**Remedial Design Report/Remedial Action Work Plan  
for the Environmental Management Disposal Facility,  
Oak Ridge, Tennessee:  
Early Site Preparation Activities**

DOE/OR/01-2934&D2

<b>Document Number:</b> DOE/OR/01-2934&D1	<b>Document Title:</b> Remedial Design Report/Remedial Action Work Plan for the Environmental Management Disposal Facility, Oak Ridge, Tennessee: Early Site Preparation Activities		
<b>Name of Reviewer:</b> Carl Froede	<b>Organization:</b> EPA	<b>Date Comments Transmitted:</b> 2-17-2023

<b>Document Number:</b> DOE/OR/01-2934&D1	<b>Document Title:</b> Remedial Design Report/Remedial Action Work Plan for the Environmental Management Disposal Facility, Oak Ridge, Tennessee: Early Site Preparation Activities		
<b>Name of Reviewer:</b> Randy Young		<b>Organization:</b> TDEC	<b>Date Comments Transmitted:</b> 1-23-2023

Fig. 2. EMDF area and existing piezometers.

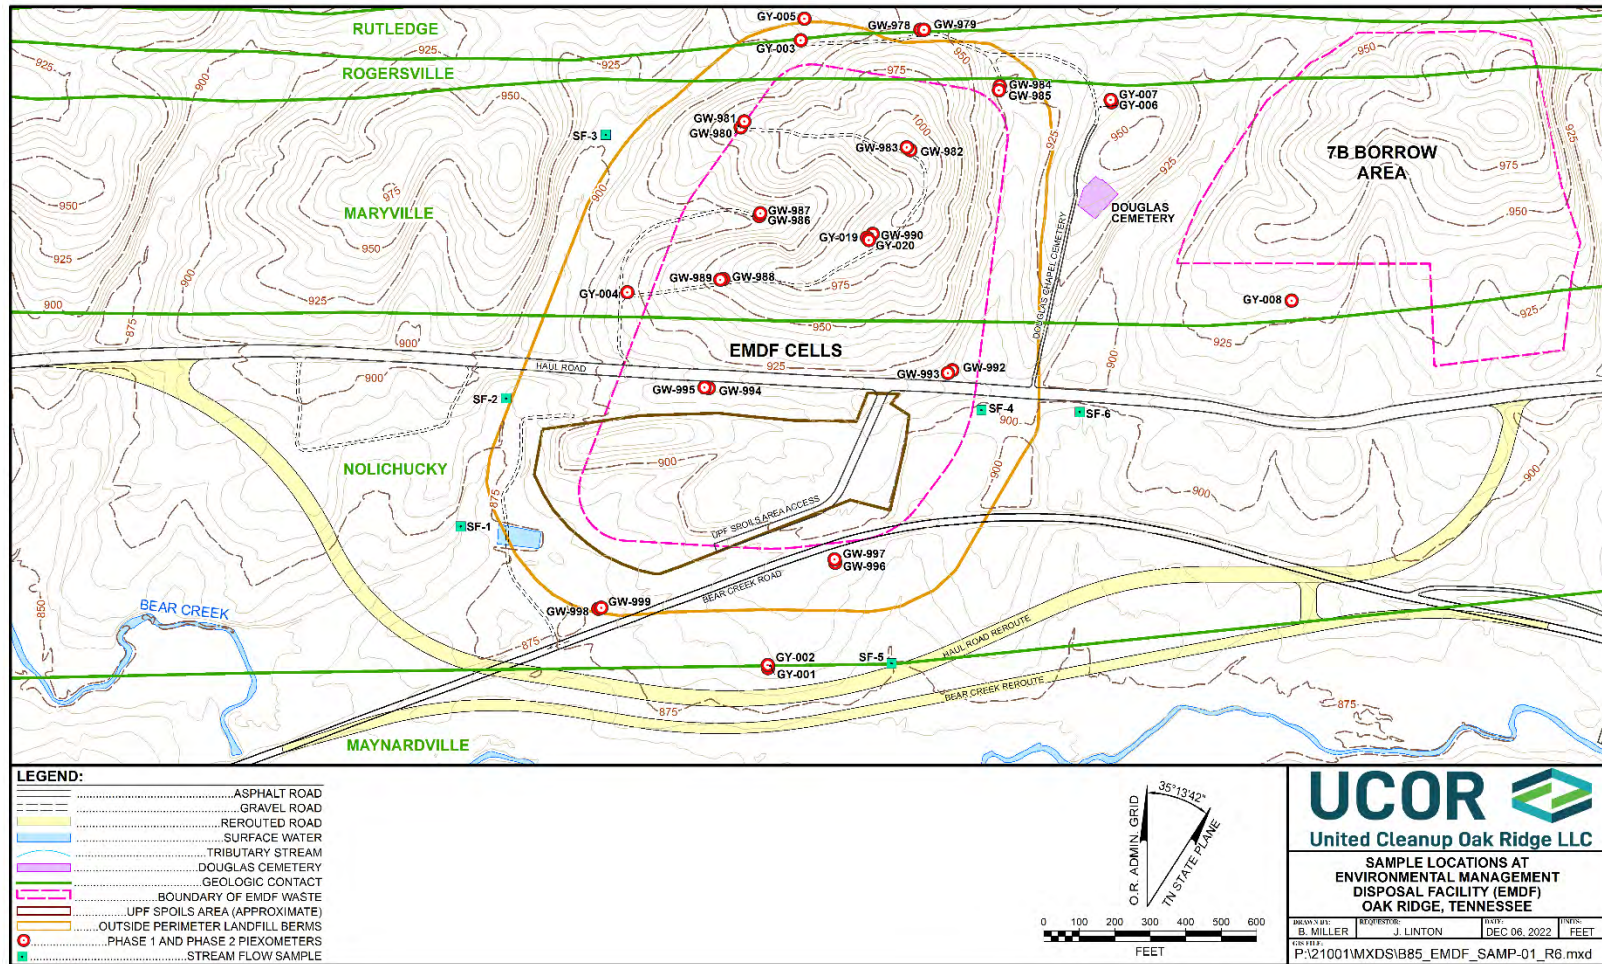
Comment No.	Sect/ Page	Comment	Response
4	Sect. 2.2 pg 5 2 <sup>nd</sup> para	<p>It is unclear whether all 32 piezometers have been monitored since 2018. Revise this paragraph for accuracy if warranted.</p> <p>Technical Memorandum 2 (TM-2) documents the installation and monitoring of 16 “Phase 1” piezometers in 2018. Although the TM-2 transmittal letter forecasts delivery of Technical Memorandum 3 (TM-3) in August 2019 to document Phase 2 data, TDEC has not found that TM-3 was ever submitted.</p>	<p>Clarification provided. The piezometers have been monitored for groundwater elevation since 2018, no change to the text is needed.</p> <p>TM-3 was not submitted. However, DOE has previously provided the relevant information on the piezometers. The Phase 2 data expected to be reported in TM-3 is primarily data that will be used for the design and will be submitted as part of the RDR/RAWP for the landfill instead of a standalone TM.</p>

Fig. 3. EMDF natural resource evaluation and ESP activities.

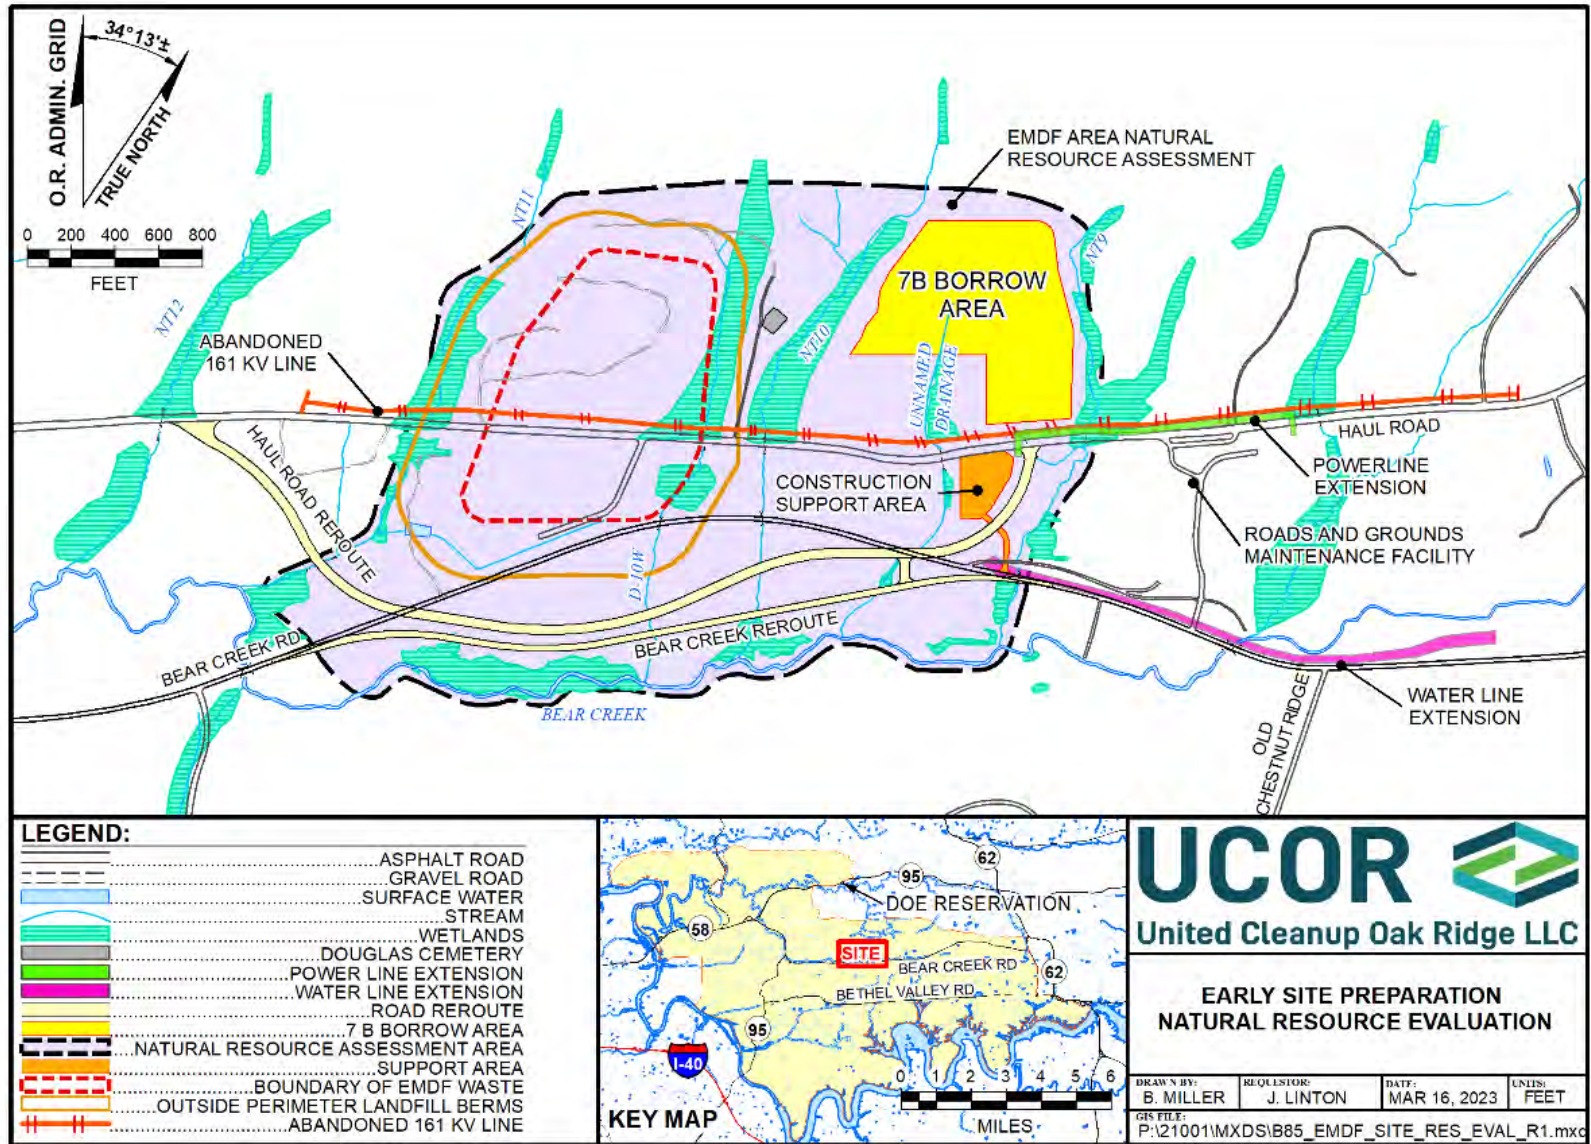
Comment No.	Sect/ Page	Comment	Response
		additional description.	
7	Sect. 2.4 pg 7	<p>Stream surveys</p> <p>As noted in this section, the project lies in a watershed with a thriving population of Tennessee dace, which the state lists as “in need of management.” Although Tennessee dace were not observed during the brief onsite surveys, consider rewording this section (and similar language in Appendix F) to indicate the stormwater controls will protect this species in streams that may be impacted by ESP activities.</p>	Agree. Text revised as suggested.
8	Sect. 2.4 pg 7 (also pgs F-6, F-13, F-16)	<p>Timber assessments</p> <p>The document discusses the lack of a recent timber inventory and cites a map in a 2018 report.<sup>1</sup> That map and related text indicate part of the ESP area was assessed for timber in 2014 and 2015.<sup>2</sup> The document under review, the Remedial Design Report/Remedial Action Work Plan (RDR/RAWP) for ESP activities, summarizes the historical timber inventory, stating that relatively short loblolly pine trees provide the dominant forest cover, consistent with timber harvesting in 2000. Other parts of the document (e.g., p. 8 and p. F-7) suggest that rare species are not typically found in areas that were harvested 23 years ago.</p> <p>Rather than relying on such assumptions, DOE should survey ESP areas for the potential presence of sensitive species known or suspected to be in the area before beginning ESP activities. TDEC’s rationale for this recommendation includes the following.</p> <p>First, as noted in Comment 9a, there is some uncertainty whether loblolly pines provide roosting habitat for bats. As noted below, the ROD addresses requirements for compliance with the ESA.</p> <p>Second, the forest composition may be more complex than suggested by the RDR/RAWP summary. The 2014-2015 inventory documents at least 36 tree species, although it is unclear how these species are distributed within the ESP area.<sup>3</sup> Ten trees measured at sample points in the area had diameters at breast height (dbh, or 4.5 feet above ground) of 30 inches or more, including a 38-inch chestnut oak.</p> <p>More than half the basal area was covered with trees that had dbh measurements of 10 inches or greater. These larger trees included tulip poplar, white oak, red maple, and sweet gum. Saplings, or trees</p>	<p>Clarification provided. The text was revised to indicate that the timber inventory completed in 2014 was used to provide additional data to supplement the timber assessment in 2018. In addition, rare species assessments were conducted as part of the 2018 surveys.</p> <p>Clarification provided. Recent walkdown with ORNL Natural Resources bat SME identified less than 50 potential bat roosting trees in the ESP areas. This information was added to the text.</p> <p>See response to first paragraph above concerning the timber assessment.</p> <p>Clarification provided. The 2018 timber assessment noted the presence of primarily loblolly pines in the ESP areas. The information provided in the comment</p>

9	pg 8 2 <sup>nd</sup> para (also pgs F-6, F-13, F-16, F-20)	<p>Rare species surveys</p> <p>a. TDEC understands the area to be cleared during ESP is forested primarily by loblolly pine trees, but there is uncertainty whether they provide roosting habitat for bats. A 2022 U.S. Fish &amp; Wildlife Service (USFWS) report states bats are flexible in selecting tree species, noting adult females form maternity colonies in many tree species with suitable cavities or bark.<sup>4</sup> The report states factors such as forest successional patterns and stand/tree structure are more crucial than tree species for determining roosting habitat.</p> <p>The ROD addresses DOE duties for compliance with the ESA, particularly with respect to several species of bats. Activities during the RD/RA phase of a remedial action must be consistent with the terms and scope of the ROD. The Species Status Assessment (SSA) report cited in the previous paragraph addresses the northern long-eared bat (NLEB). The SSA is not a regulatory document and only provides guidance. When the ROD was signed, the NLEB was list as “threatened,” but a rulemaking was already in process to “uplist” the species. Now the final rule has been published and will become effective at the end of January 2023.<sup>5</sup> The final rulemaking itself, 87 FR 73488, determines the enforceable legal restrictions that apply to the species in its new status as an endangered species. These requirements are outlined at the end of the final rule, 87 FR 73488-73502-3 (November 30, 2022).</p> <p>For this reason, TDEC strongly urges DOE to complete necessary tree removal during the winter, i.e., by mid-March, when bats are</p>	<p>Clarification provided. Recent walkdown with ORNL Natural Resources bat SME identified less than 50 potential bat roosting trees in ESP area. Informal consultation with USF&amp;WS determined there will be no adverse impact.</p> <p>No response required.</p> <p>Clarification provided. DOE has completed the</p>

Fig. 6. EMDF ESP project organization.

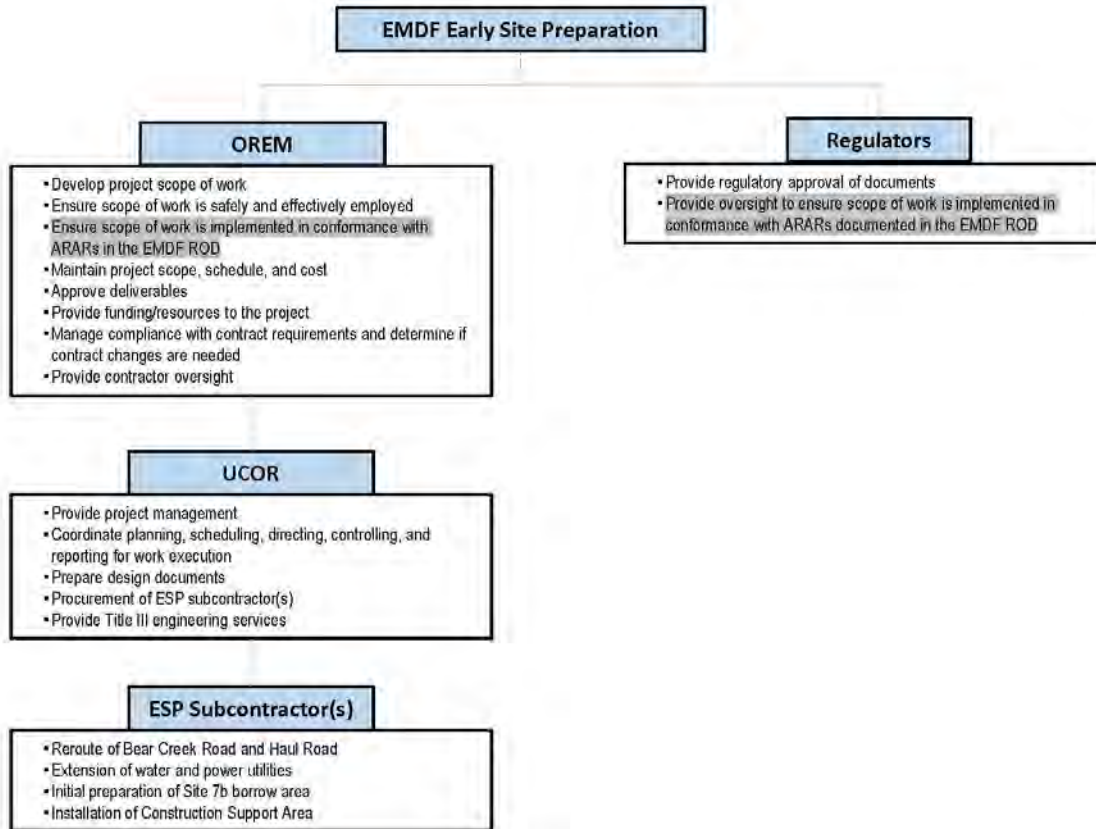
Comment No.	Sect/ Page	Comment	Response
15.	Sect. 7.1.2 Fig. 6 pg 23	a. Under <i>OREM</i> , add the following text.  <i>Ensure scope of work is implemented in conformance with ARARs in the ROD.</i>  b. Under <i>Regulators</i> , add the following text.  <i>Provide oversight to ensure scope of work is implemented in conformance with ARARs documented in the ROD.</i>	Agree. Text revised as suggested.
16	Sect. 7.2 Table 2 pg 24	The schedule indicates much of the ESP work will occur during the winter wet season. Therefore, another section of the document should describe how DOE will respond to high-intensity rainfall, flash flooding, and excess stormwater that will need to be managed during such events.	Clarification provided. The following text was added in Chap. 5: “The ESP design is based on runoff from a 25-year, 24-hour storm and considers the runoff from a 100-year, 24-hour storm. Erosion control is in accordance with the ESP Stormwater Management Requirements document; sediment and erosion control measures are designed in accordance with the EMDF ROD ARARs, including guidance presented in the <i>Tennessee Erosion and Sediment Control Handbook</i> .”
